From: Wayne Miller [Miller.Wayne@azdeq.gov]
Sent: 7/7/2016 8:22:20 PM
To: d'Almeida, Carolyn K. [dAlmeida.Carolyn@epa.gov]
Subject: 2016-7-7- wafb - ST12 - thanks - groundwater plume contours over time-

From: d'Almeida, Carolyn K. [mailto:dAlmeida.Carolyn@epa.gov]
Sent: Thursday, July 07, 2016 11:19 AM
To: Davis, Eva <Davis.Eva@epa.gov>; Dan Pope <DPope@css-dynamac.com>; Wayne Miller <Miller.Wayne@azdeq.gov>
Cc: Henning, Loren <Henning.Loren@epa.gov>; Butler, Thomas <Butler.Thomas@epa.gov>; Levine, Herb <Levine.Herb@epa.gov>; Brasaemle, Karla <KBrasaemle@TechLawInc.com>; ARohrbaugh@TechLawInc.com
Subject: 2016-7-7- wafb - ST12 groundwater plume contours over time- cda epa

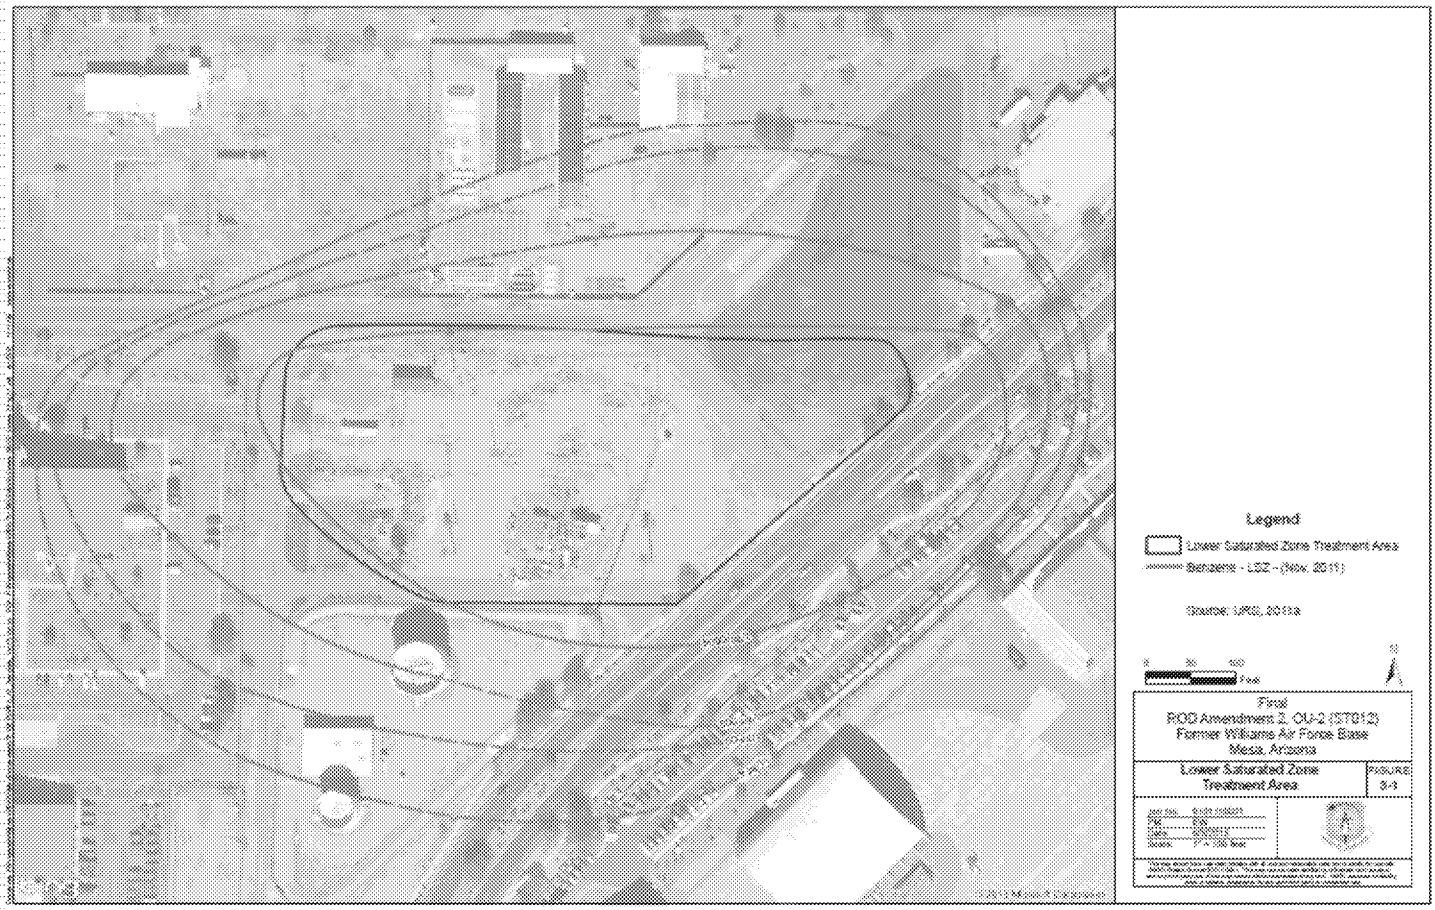
This figure below is from the 2013 ROD amendment - note the extent of the 5000 ppb contour line
